Formal Objection to the proposed Veolia Woodlawn
Advanced Energy Recovery Centre (ARC)

This submission presents CATTI's grounds for objecting to Veolia's proposed State Significant Development application SSD-21184278 – construction and operation of a waste to energy (WTE) incinerator with a capacity to burn 380,000 tonnes per annum of municipal solid waste and commercial & industrial waste and generate approximately 30MW of electrical energy.

Figure 3.6, Traffic Impact Assessment, page 24.

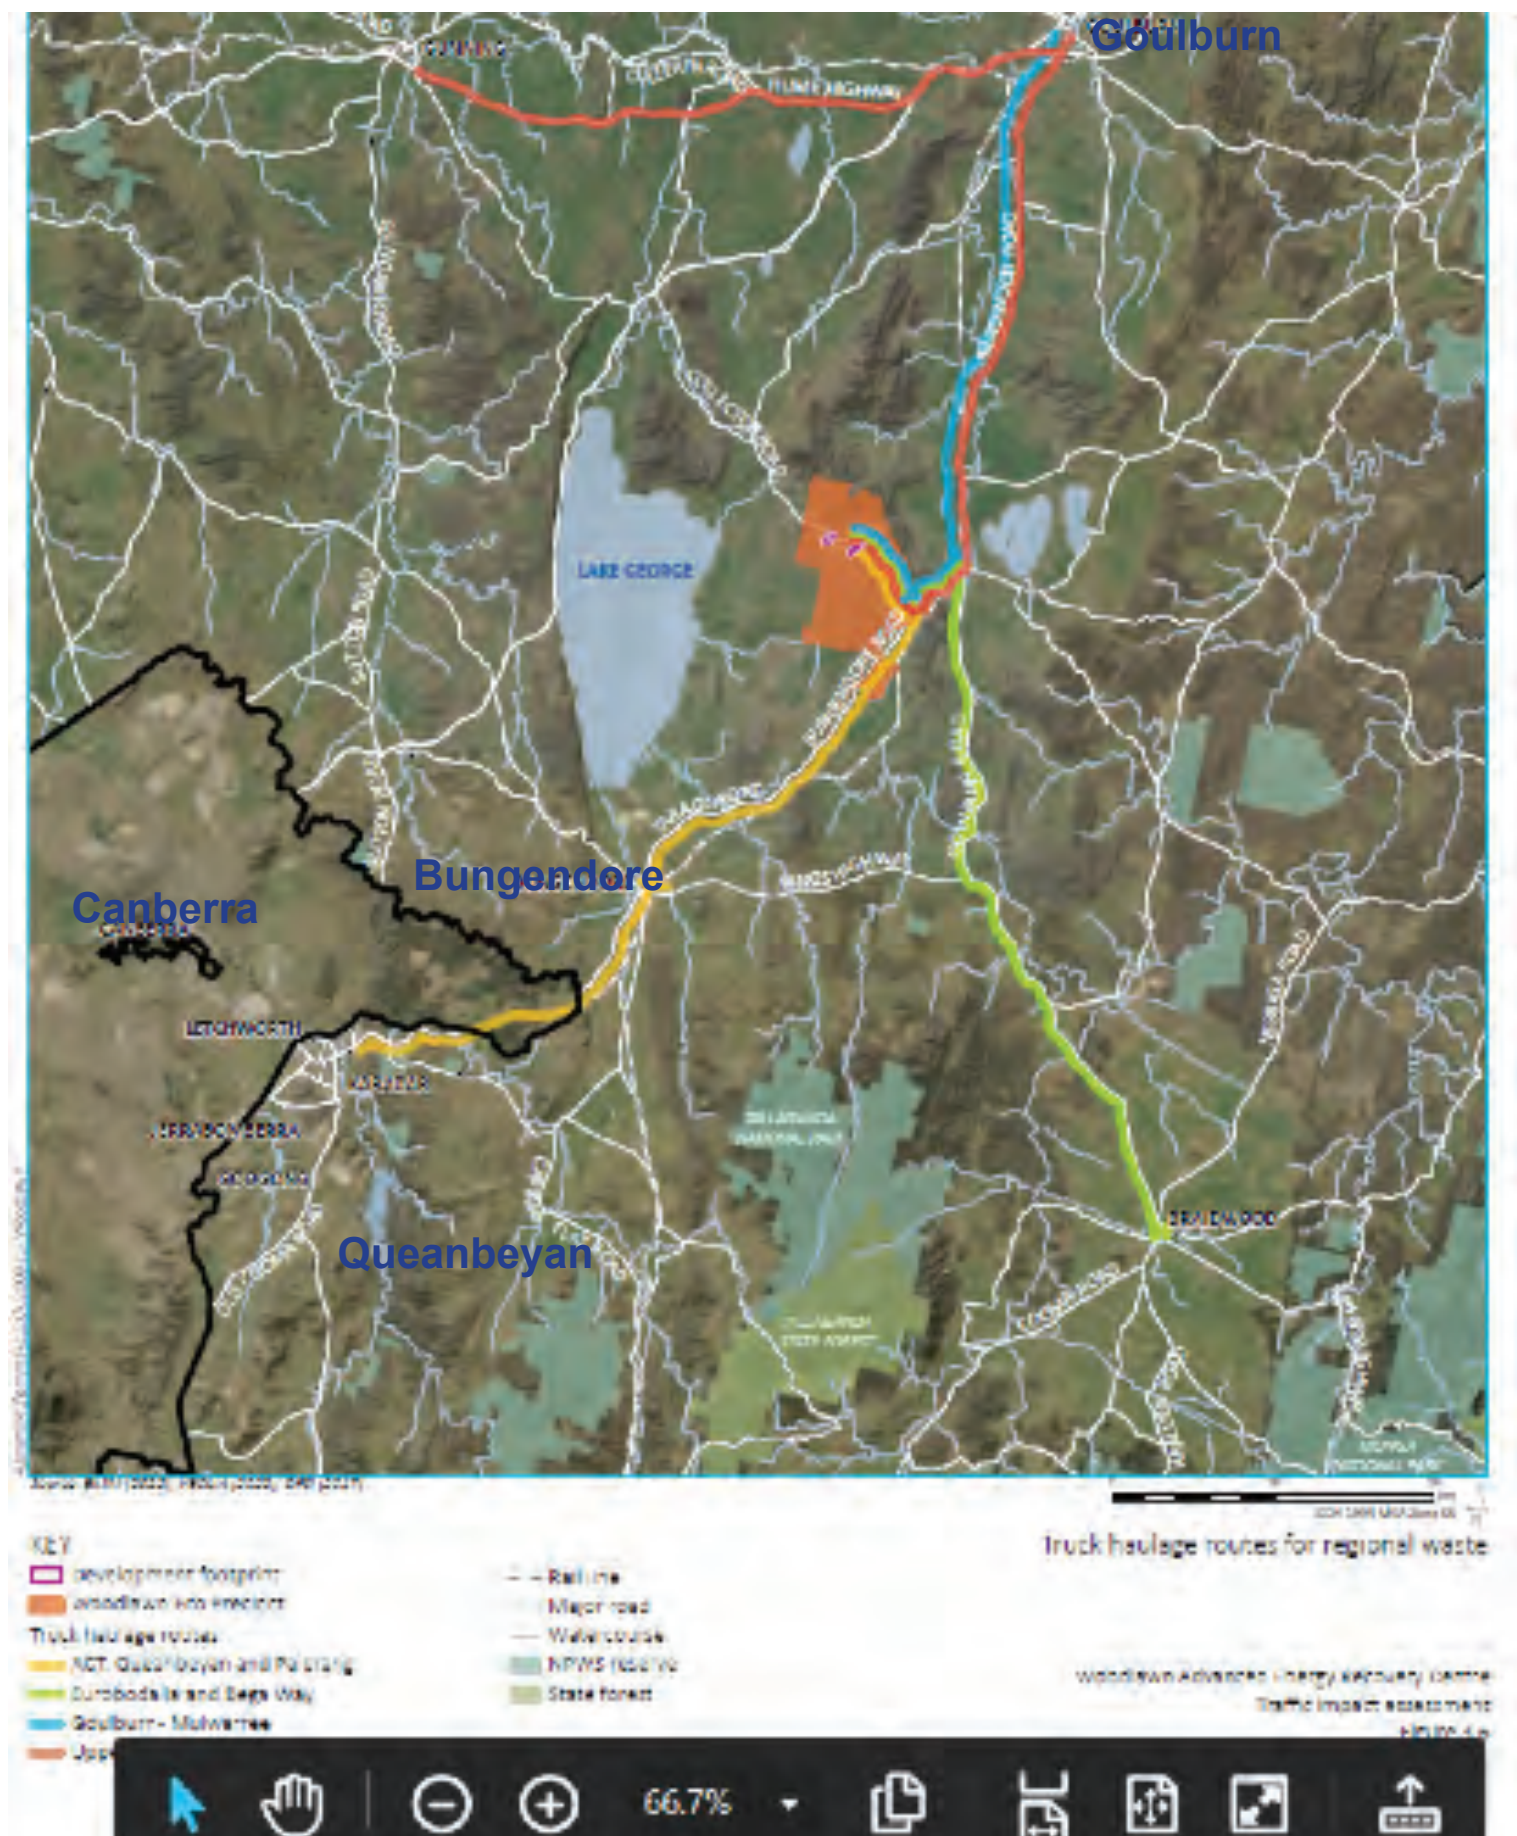
As Figure 3.6 of the traffic impact assessment (page 24) demonstrates, every truck travelling to the site travels along Tarago-Bungendore road. Trucks travelling from ACT/Queanbeyan/Palerang travel north until the Collector Road intersection, while the Eurobodalla/Bega, Goulburn-Mulwaree, Upper Lachlan and Yass Valley trucks travel through the centre of Tarago itself and then south along Tarago road and past the IMF to Collector Road.

Figure 7.1 (Appendix Y, Biodiversity Development Assessment Report, page 56)

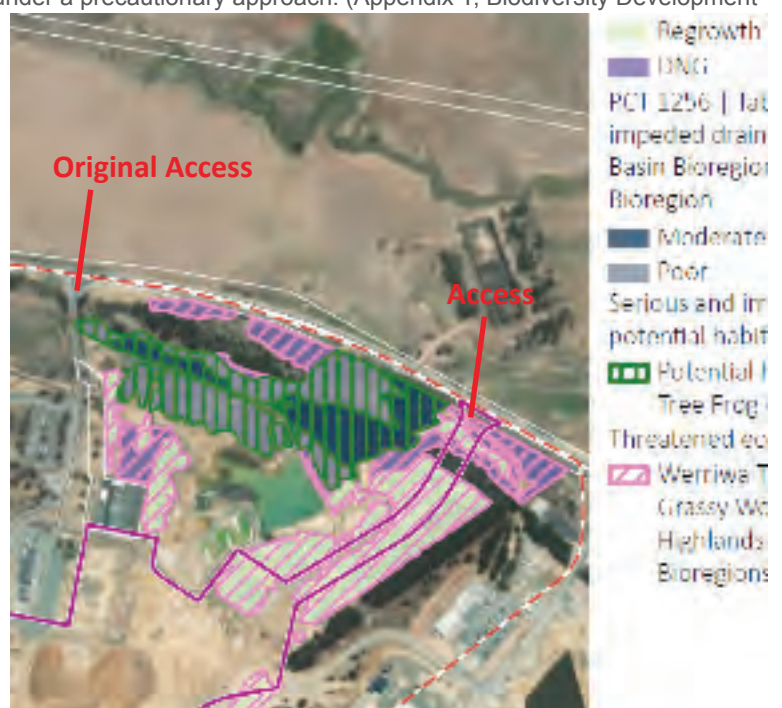
- The ARC access road was originally placed through the wetland PCT 1256, but was then redesigned so that the frog habitat is now adjacent to the subject land. The habitat appears visibly adjacent to the ARC access road in Figure 7.1 (Appendix Y, Biodiversity Development Assessment Report, page 56).

Why was a full assessment not made for this species given the proximity of habitat to the development and the report's acknowledgement that "foraging and shelter habitat" will be impacted? (Table 8.10, Biodiversity Development Assessment Report, page 90).
